FIRE SAFETY INSPECTION REPORT

Occupant Name:	Heron Pond	Inspection Date:	1/19/2023
Address:	8439 Southwest 5 Street	Inspected By:	Victor Santos
Suite:	Bldg. - #12	Property Use Type:	Multifamily dwelling
Occupant Number:		InspectionType:	Annual Fire Alarm (FAS), Annual Fire and Life Safety Inspection
Occ. Sq. Ft.:	20000	Number of AEDs:	0

1.1 - 10.1.4.1.

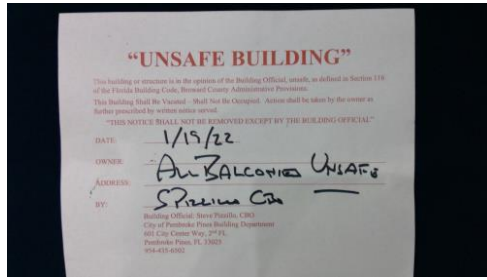
Deficiency		FL NFPA 01 2018 Chapter 10 General Safety Requirements	10.1.4.1 - Excerpt: Where structural elements have visible damage, the AHJ shall... (see photo 1.1)
-------------------	--	---	---

Inspector Comments: ***The noted structural damages have been referred to the City's Building Official and Structural Chief for evaluation of possible unsafe conditions. A site visit with structural inspectors and the Building Official to demonstrate areas of concern was conducted. Following the site visit, a structural engineer was consulted and in conjunction with the Building Official, deemed each patio/balcony area unsafe. The Building Official instructed Xochitl Alvarez, the property manager, to produce an analysis and proposal completed by a structural engineer for conditions and repairs within 48 hours. Each building and unit had an "Unsafe Building" notice posted on the front door as well as verbally communicated with residents who were home at the time. Residents were instructed that due to the unsafe conditions, they are to remain clear of the patio/balcony area until further notice is given.***
